**ADDENDUM #2**

<b>Project</b>	TA Blakelock High School Renovations	<b>Project No.</b>	2215-C
<b>Location</b>	1160 Rebecca Street, Oakville, ON	<b>Date of Issue</b>	2025 04 25
<b>Owner</b>	Halton District School Board	<b>File</b>	2215/7.1.3

This Addendum forms part of the Contract Documents and amends the original Drawings and Specifications, dated 2025 04 17, and all preceding Addenda, as noted below.

**A2-3 DRAWING A107 SECTION DETAILS**

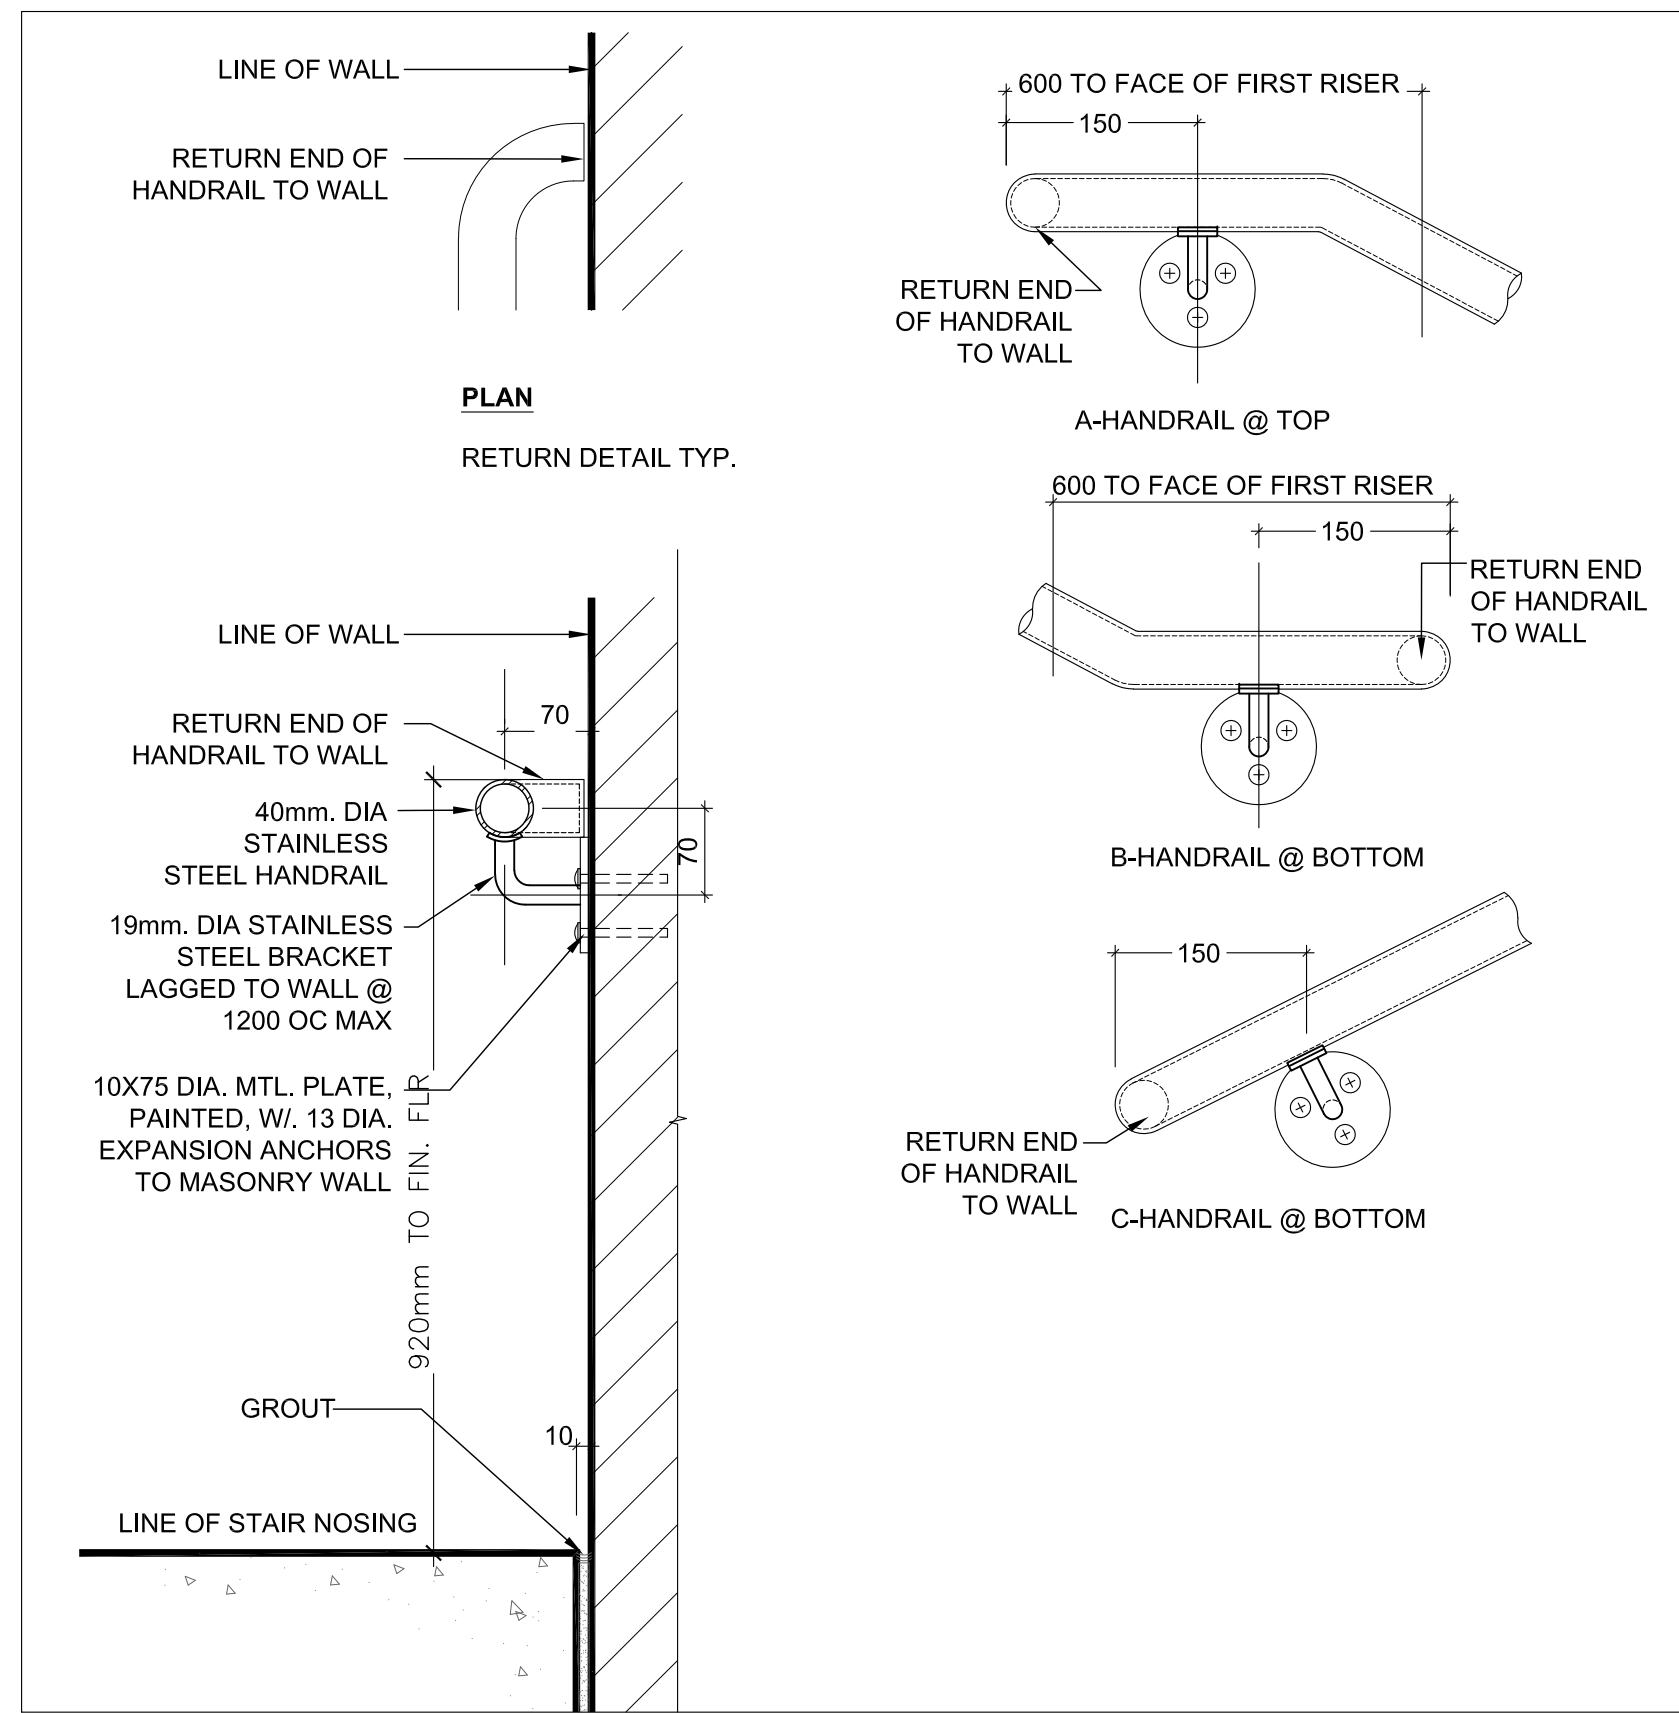
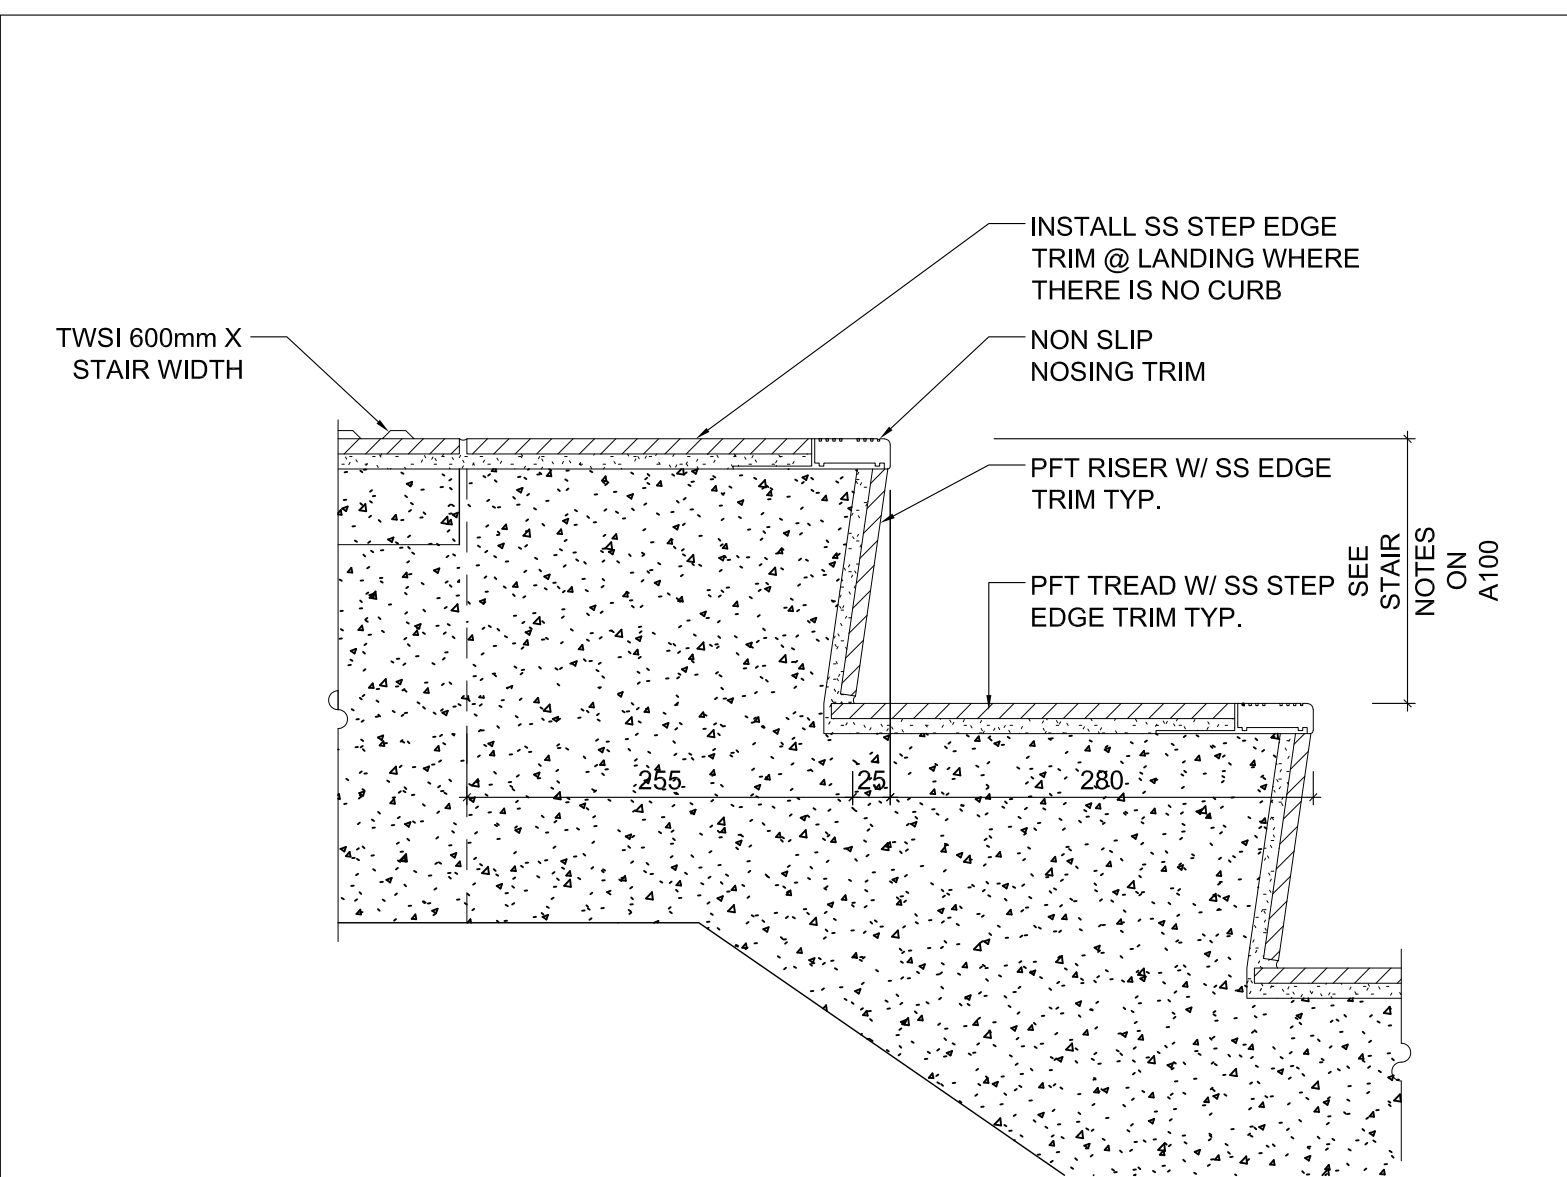
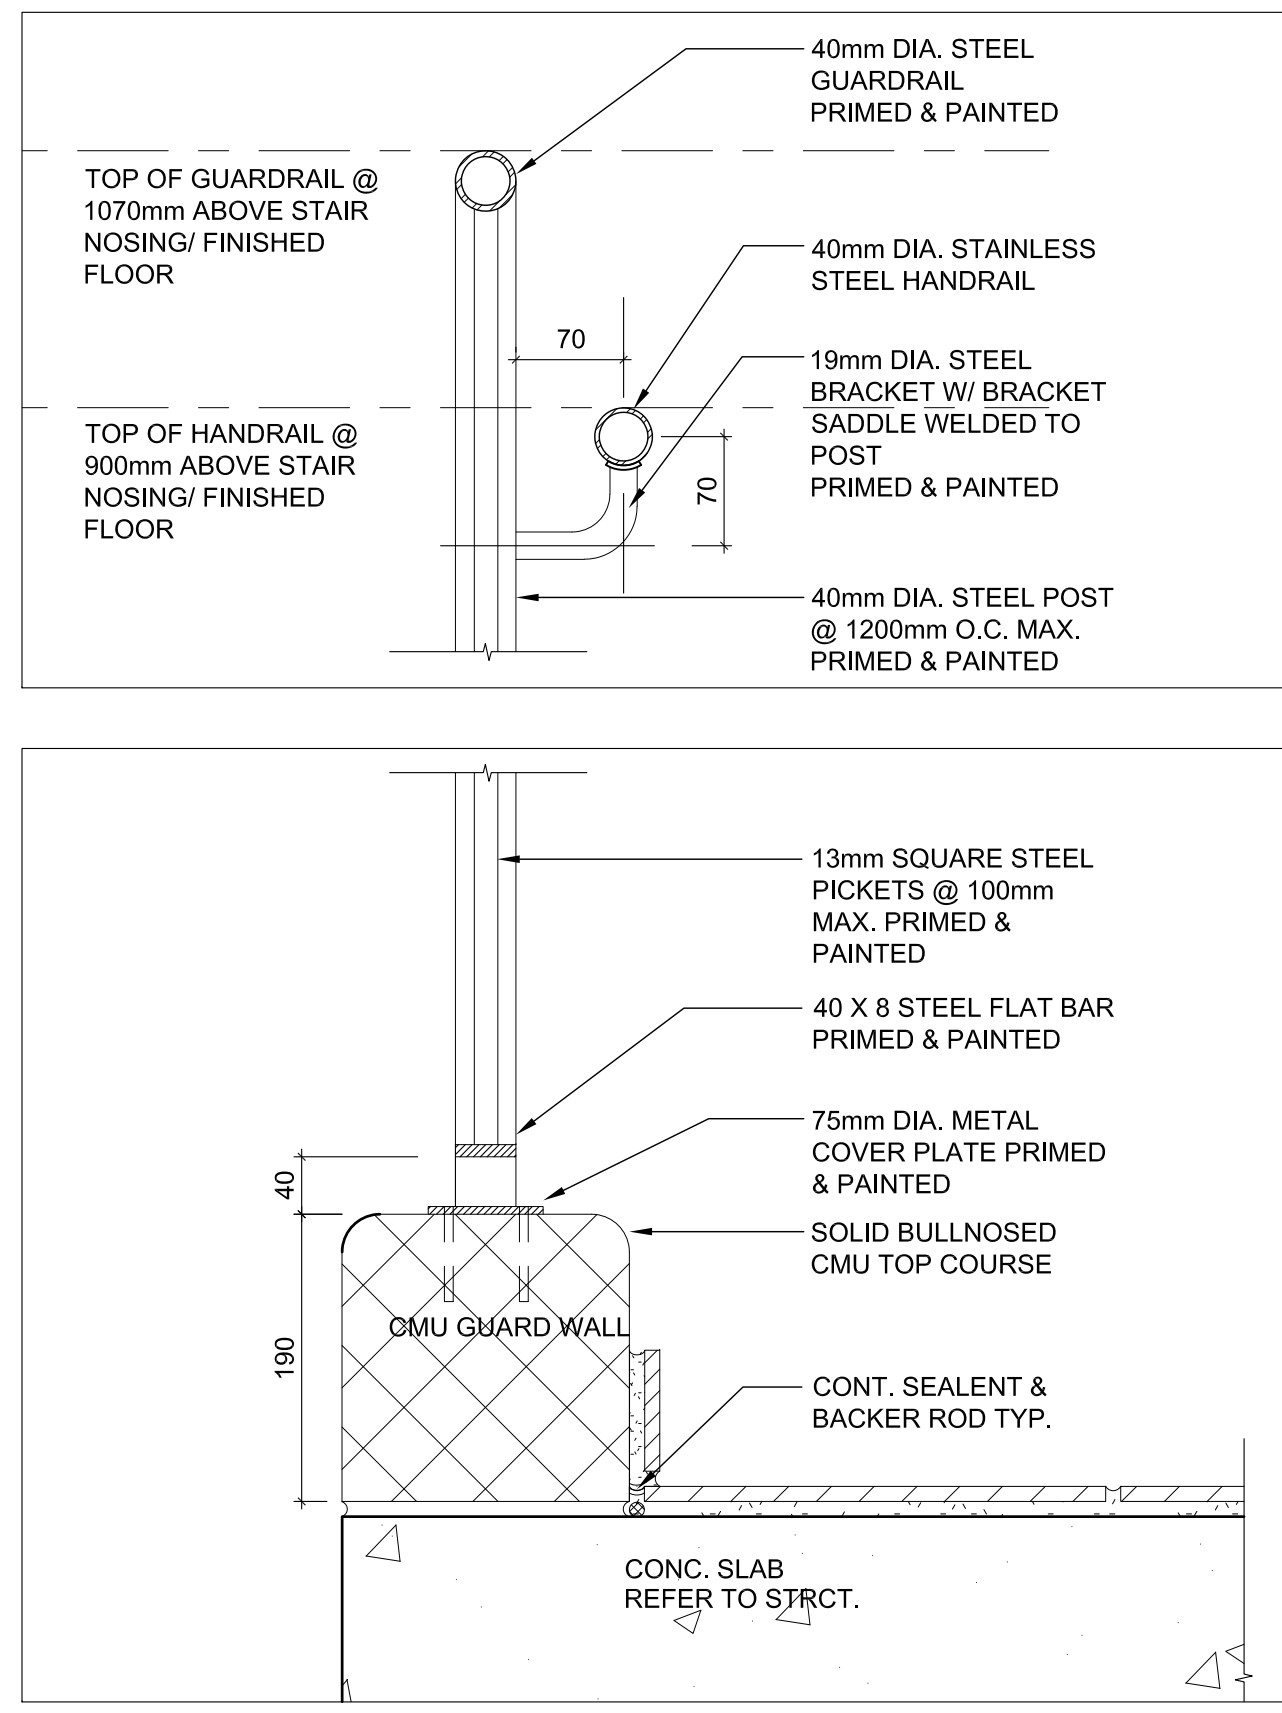
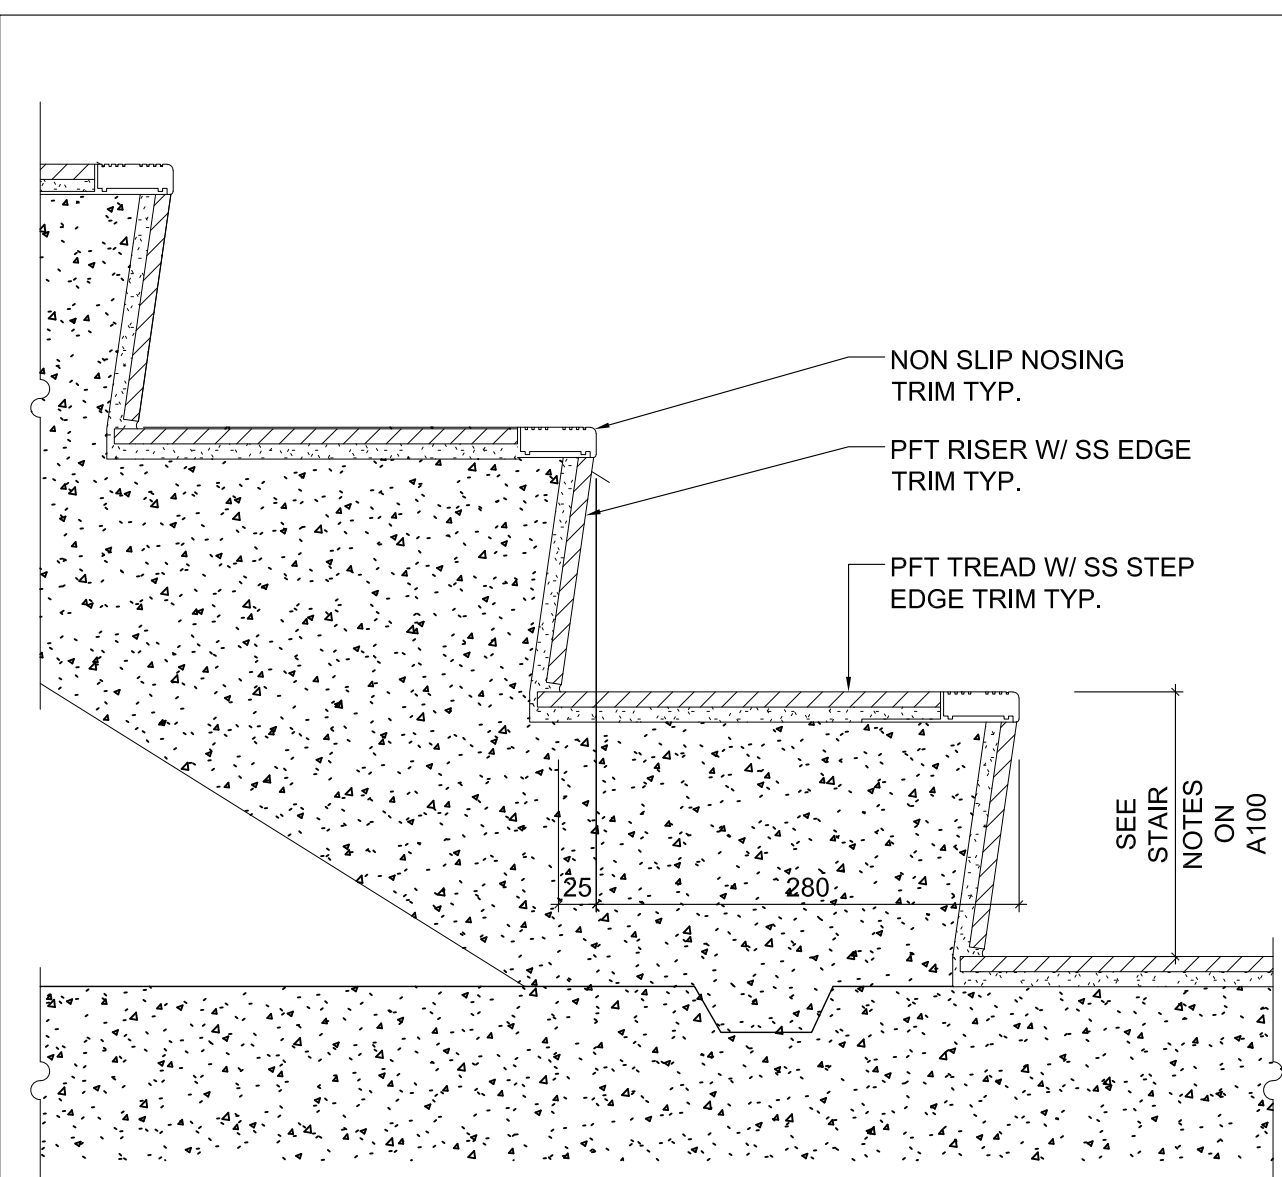
- .1 New drawing added for section details and typical details.
